# PERMIT

## SEWAGE DISPOSAL SYSTEM

**HOWARD COUNTY HEALTH DEPARTMENT**  
**BUREAU OF ENVIRONMENTAL HEALTH**  
461-9933 313-2640

SUBDIVISION Breezewood Farms LOT 25 ROAD 10633 Breezewood Circle

#1 SOIL PROFILE

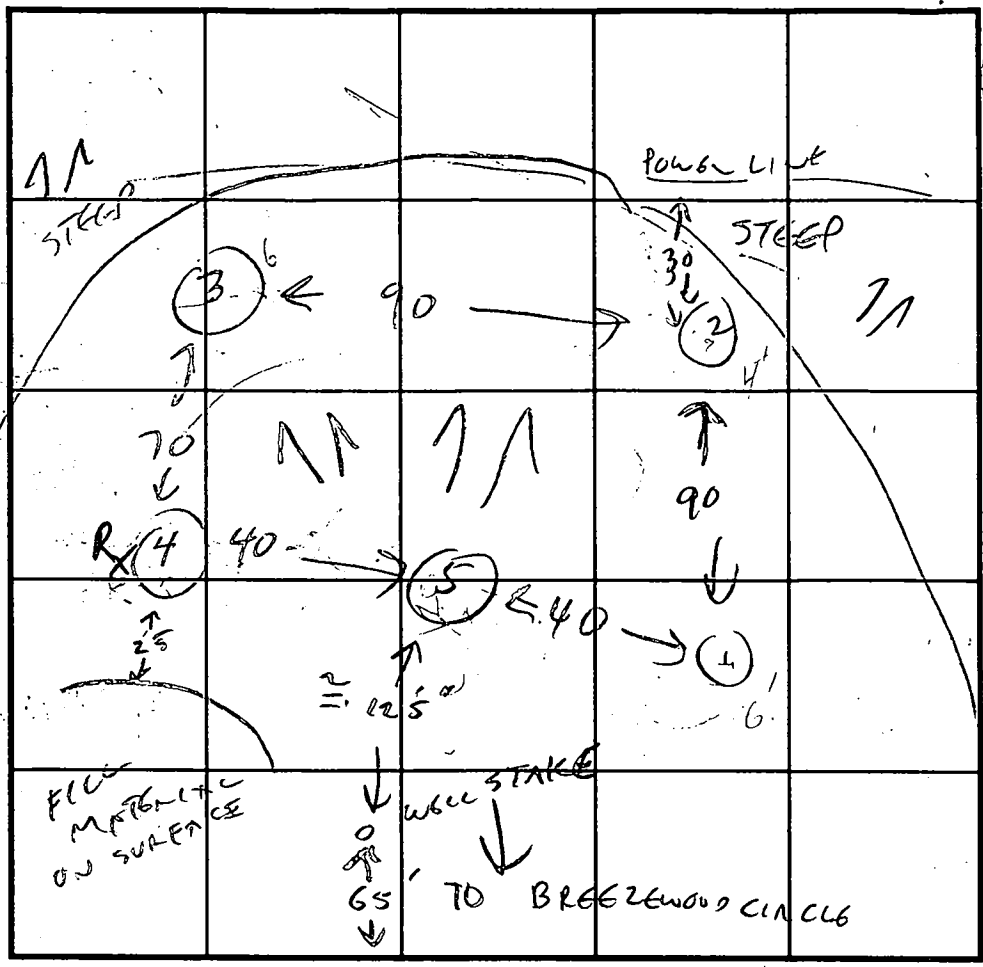
DATE	TEST NO.	DEPTH	PRE-WET		TEST - 1" DROP		TIME
			START	STOP	START	STOP	
11/27/95	1	2 6	10:52 BEDROCK	10:55	10:55	10:59	15 min
	2	18" 4	11:09 BEDROCK	11:19	11:19	11:45	26 min
	3	18"	11:18	11:24	11:24	11:40	16 min
	4	VIS. OK	2-6	THEN	BEDROCK		
	5	BEDROCK AT 18"			FAILS		
		2 VIS OK	2-10	(LIKELY OK TO 12')			
			BOMB ROCK AT 10' - EXPECT BEDROCK AT 12'

REMARKS VARIABLE + LIMITED DEPTH TO BEDROCK, PLACE 12' DIAMETER DAYWELL, TYPE OF SOIL INVESTIGATOR'S BOTTOM AT HOLE 5 - THEN VERY SHALLOW TRENCHES AS REQ'D.  
 TESTED BY Willis ALSO PRESENT OWING - PUBLIC CONTRACTOR  
 TRENCH DESIGN DATA: AVERAGE PERCOLATION TIME \_\_\_\_\_ TRENCH WIDTH \_\_\_\_\_  
 INLET DEPTH \_\_\_\_\_ MAXIMUM BOTTOM DEPTH \_\_\_\_\_ SQ. FT./BEDROOM \_\_\_\_\_

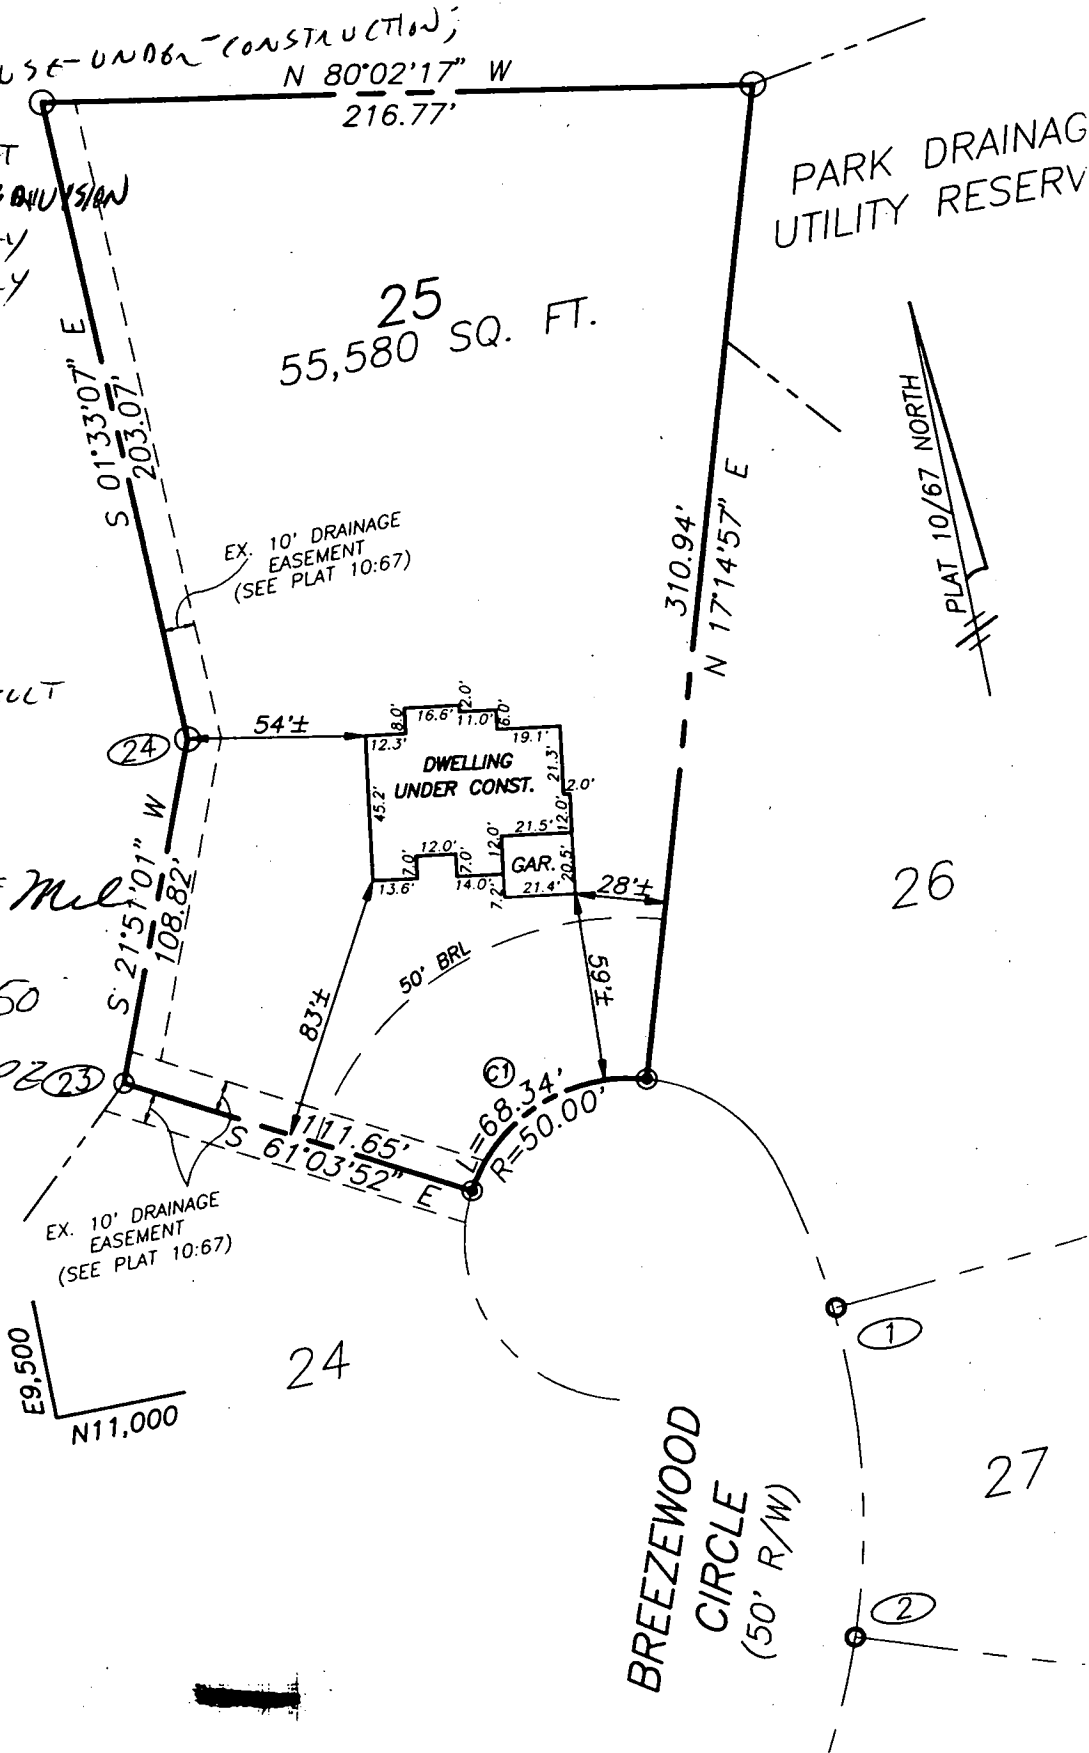
NOTE TO FILE: HOUSE UNDER CONSTRUCTION;  
N 80°02'17" W  
216.77'

APPLICANT'S REQUIREMENT  
IS TO SUBMIT RESUBDIVISION  
PLAT FOR THIS PROPERTY  
TO RESOLVE A NECESSARY  
CHANGE IN B.R.L.

ORIGINAL SUBDIVISION  
WAS NOT  
SUBJECT TO  
REQUIREMENT  
FOR 10,000  
SEWAGE EASEMENT,  
AND IT WILL BE DIFFICULT  
TO ESTABLISH ONE.  
PLEASE ADVISE AS TO  
HOW TO PROCEED

- BRL was 75 -  
changing to 50
- Someone at DPZ put 1

**REVISED**

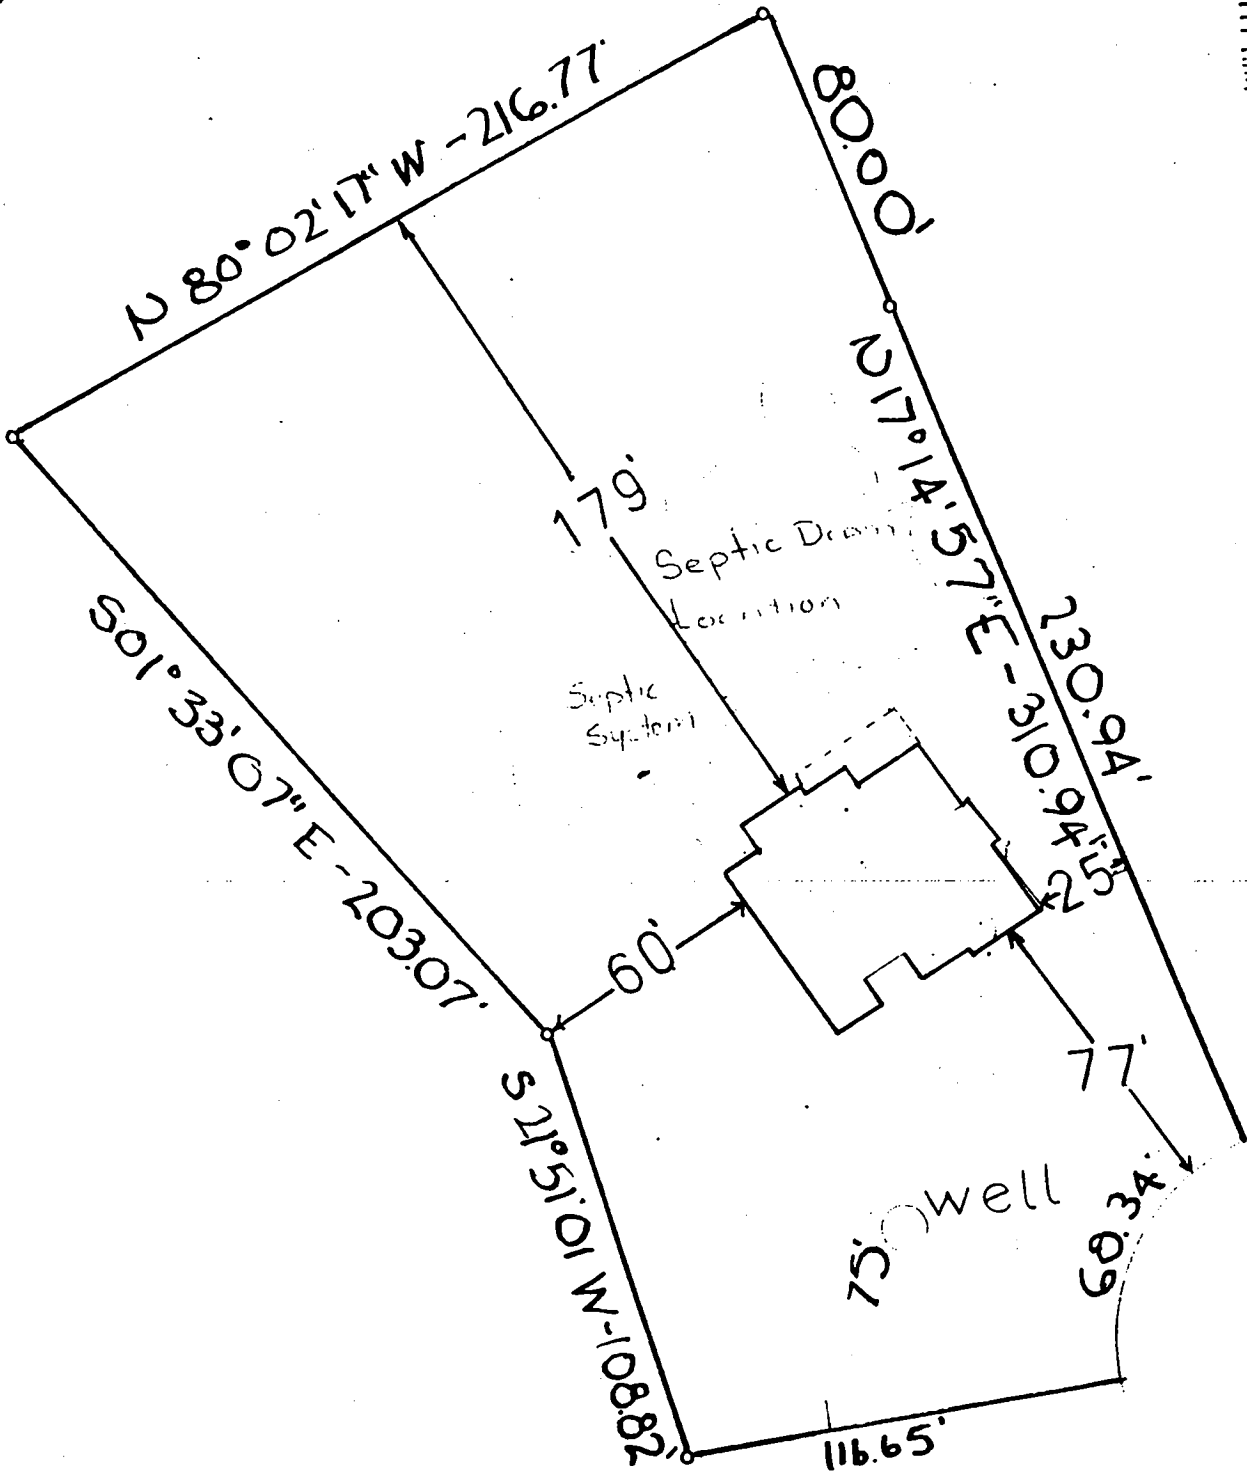
These are the revised footprints that we spoke with on  
the phone. And I have spoke with Dan and seen in  
person. Subject # B00063811.

Comments: Revised foot print

3/11/97 Revision OK.  
Sonia & [Signature]
